## ADDENDUM NO. 2

**Date:** Friday, April 24, 2025  
**Project Name:** Automated Weather Observing System Replacement  
**Owner:** Boca Raton Airport Authority  
**Owner Project No.:** 2025-BRAA-005  
**Garver Project No.** 2401228

BOCA RATON AIRPORT AUTHORITY  
AWOS REPLACEMENT

PHOTO 10 - 2ND LEVEL EQUIPMENT ROOM  
NOT TO SCALE

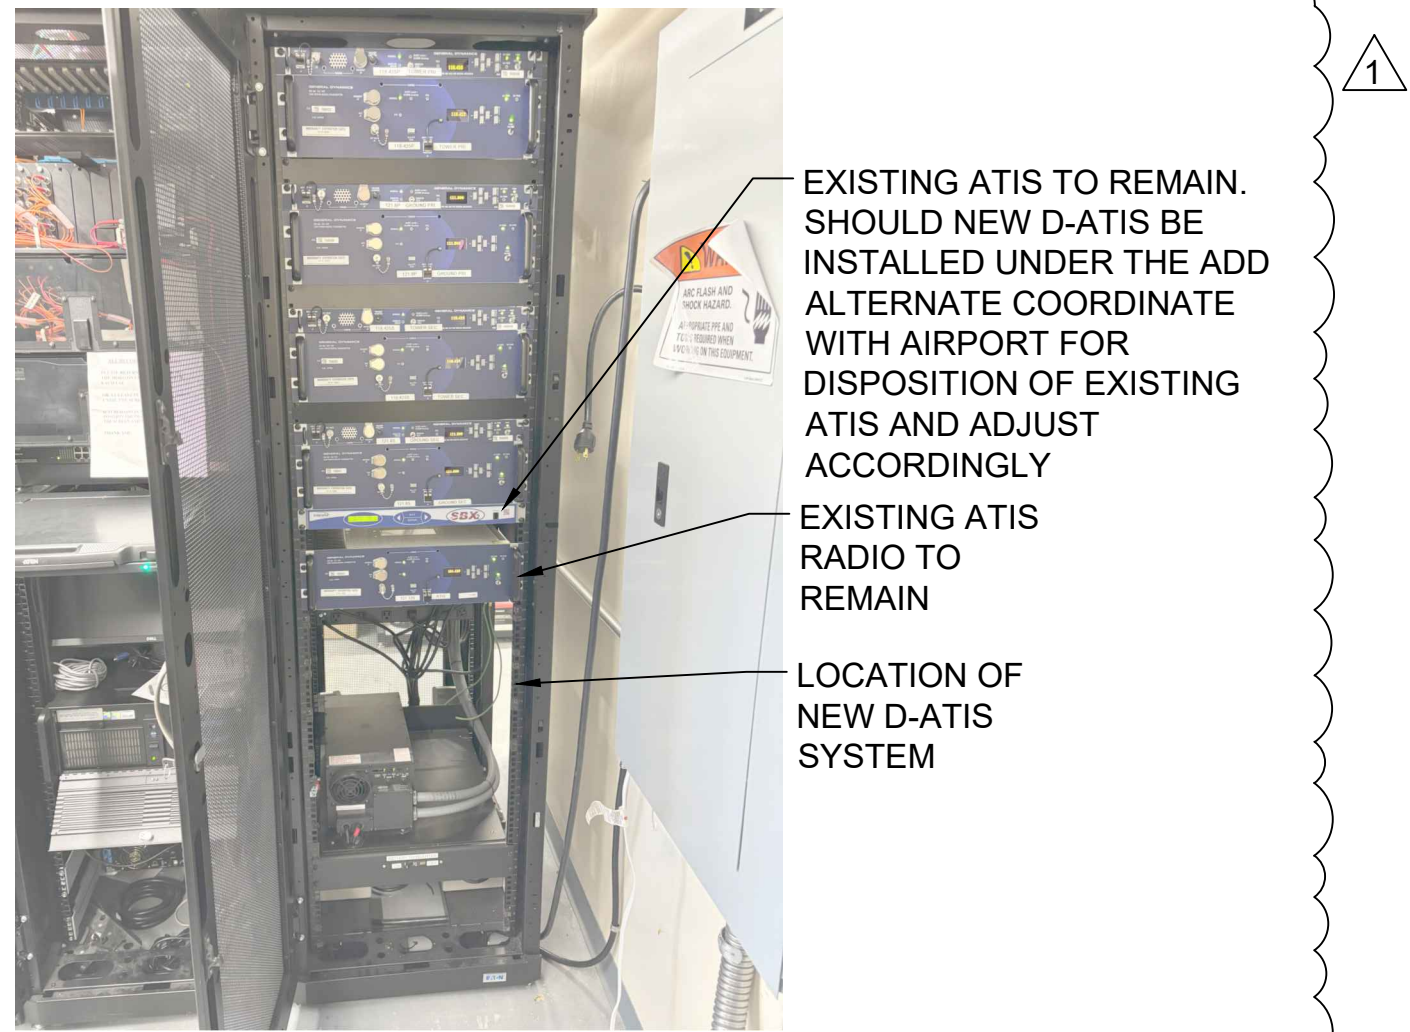
- Sheet E202: Plan revisions to incorporate additional photos along with other miscellaneous changes.
  - Sheet E203: Plan revisions to incorporate a new D-ATIS system along with other miscellaneous changes.

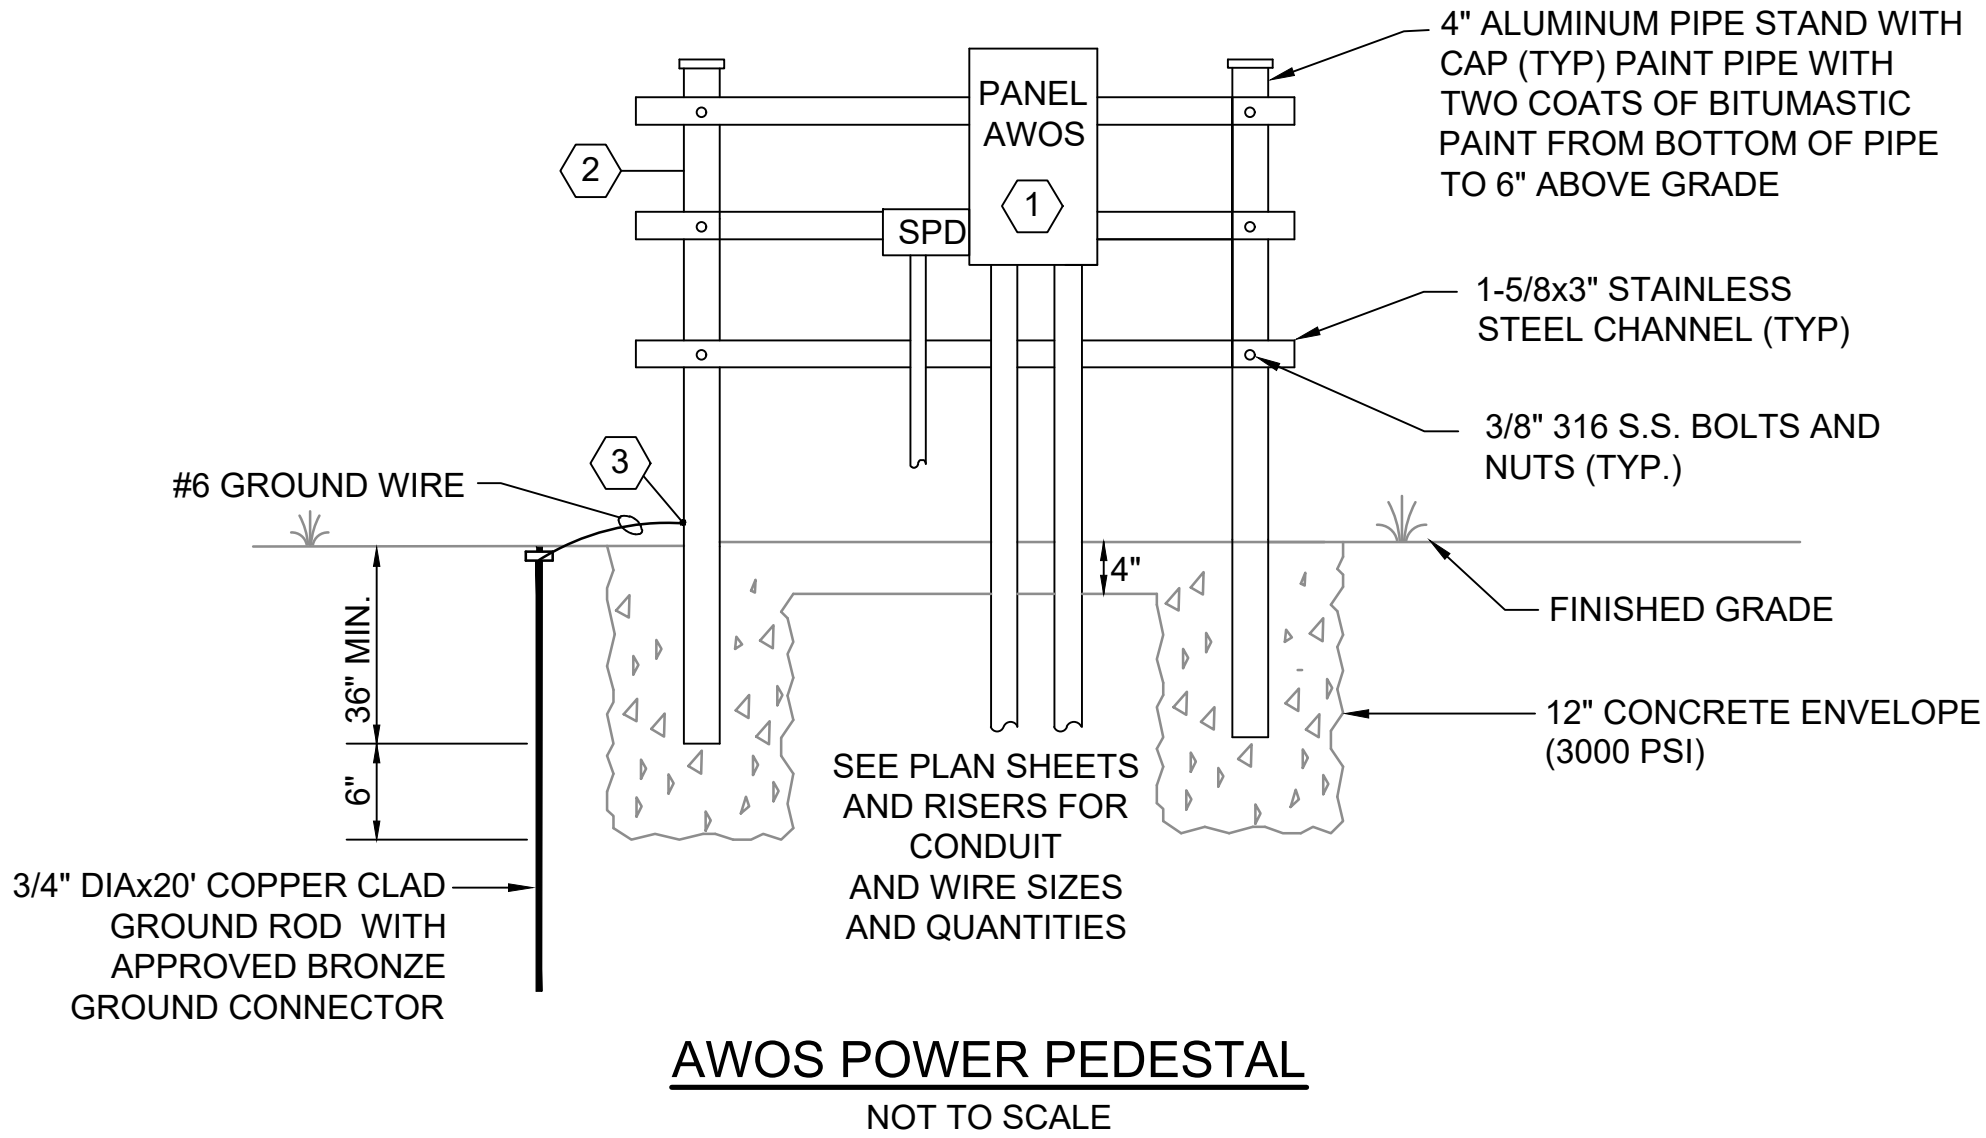
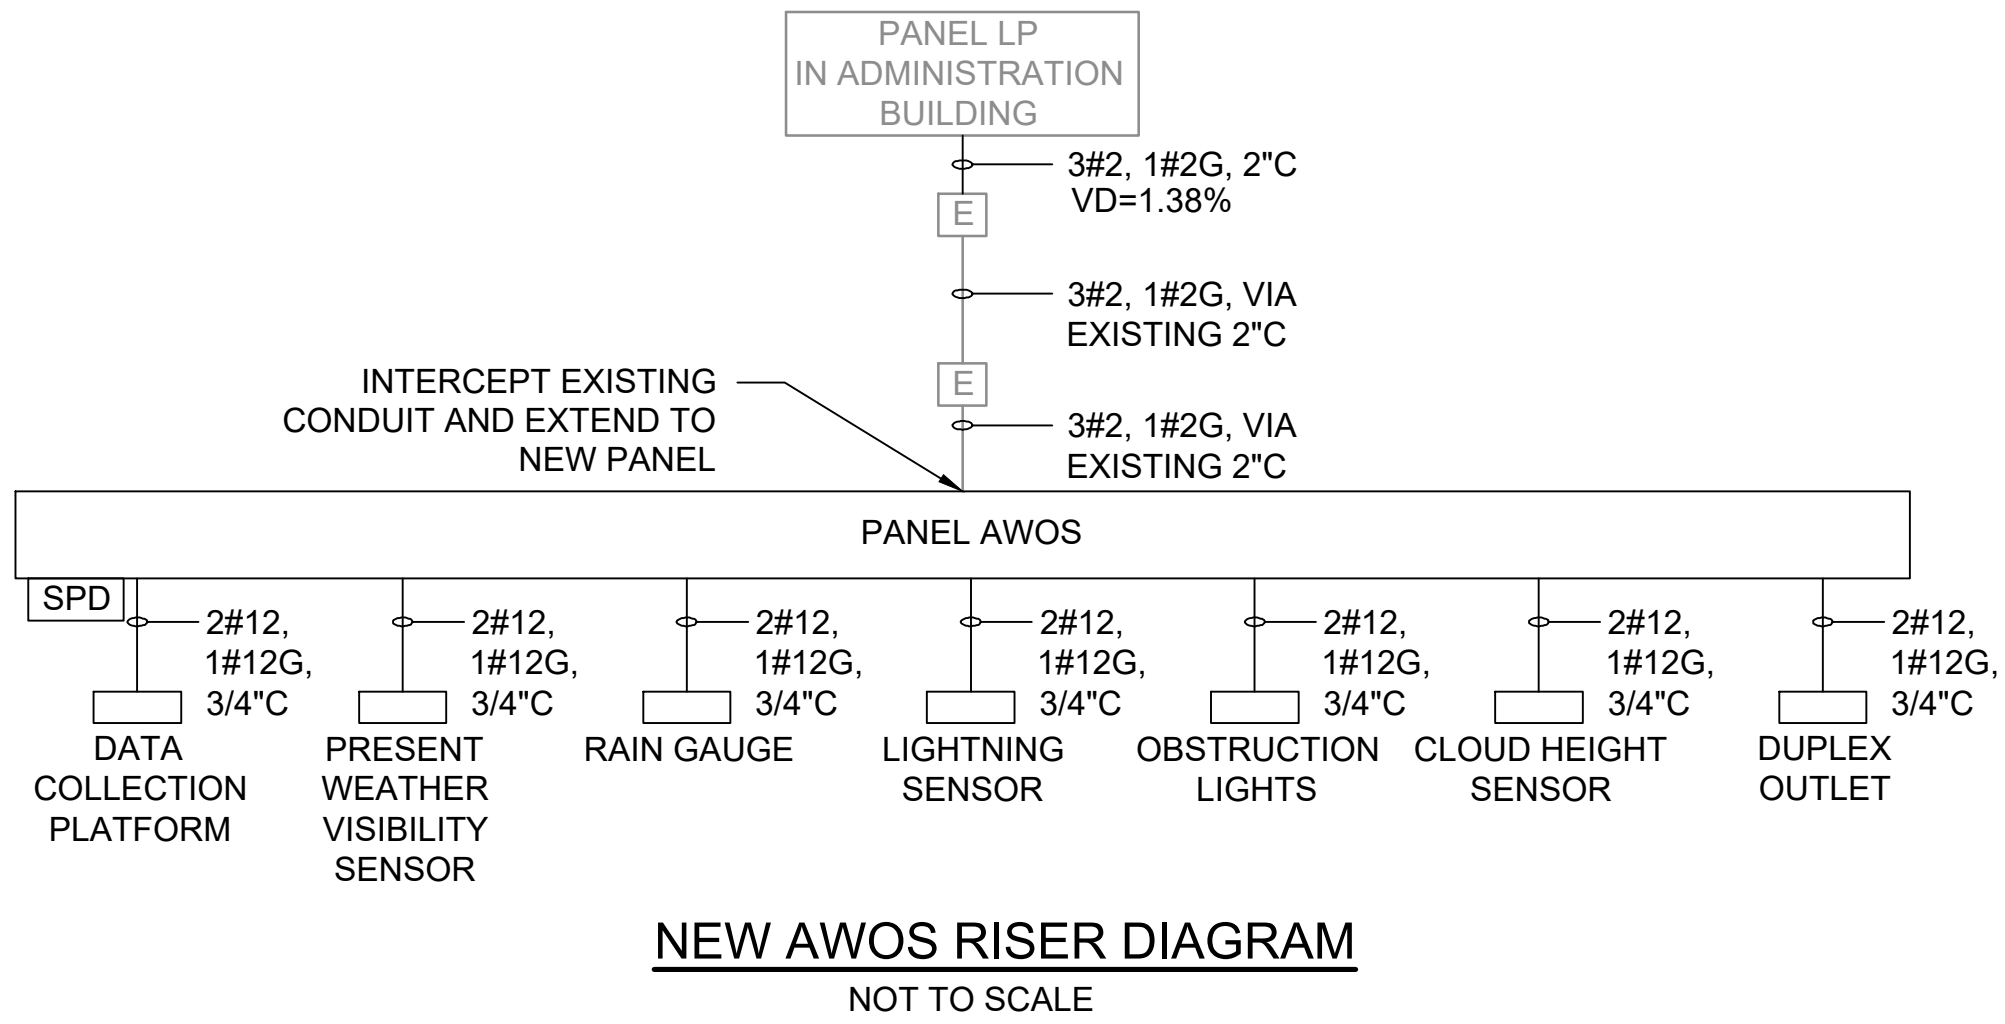
- Sheet E001: Plan revisions to incorporate a new D-ATIS system along with other miscellaneous changes.
  - Sheet E201: Plan revisions to riser diagram for incorporation of additional information.

- CONTRACTOR SHALL PROVIDE AND INSTALL AN INTERFACE BETWEEN THE AWOS AND ATIS TO ALLOW FOR THE ATIS TO BROADCAST DURING AIR TRAFFIC CONTROL TOWER (ATCT) HOURS OF OPERATION (0700-2300) AND THE AWOS TO BROADCAST WHEN ATCT IS OUTSIDE THE HOURS OF OPERATION (2300-0700).

- CONTRACTOR SHALL PROVIDE AND INSTALL A NEW DATALINK AUTOMATIC TERMINAL INFORMATION SERVICE (D-ATIS) SYSTEM WITH OPERATOR WORK STATION, MOUNTING HARDWARE, CABLING AND GROUNDING. OPERATOR WORK STATION SHALL INCLUDE A TOUCH SCREEN WITH MICROPHONE AND BE LOCATED IN THE TOWER CAB AND RACK MOUNTED D-ATIS SERVERS LOCATED IN THE EQUIPMENT ROOM. CONNECT D-ATIS TO NEW AWOS AND EXISTING VHF RADIO, PHONE LINES, LEGAL REORDER, VOICE SWITCH AND MASTER CLOCK SYSTEMS AND PROVIDE ALL PROGRAMMING AS NECESSARY FOR A COMPLETE WORKING SYSTEM IN PLACE. SUPPLY TWO DAYS (4 HOURS EACH) OF MANUFACTURER TRAINING TO AIR TRAFFIC CONTROLLERS.
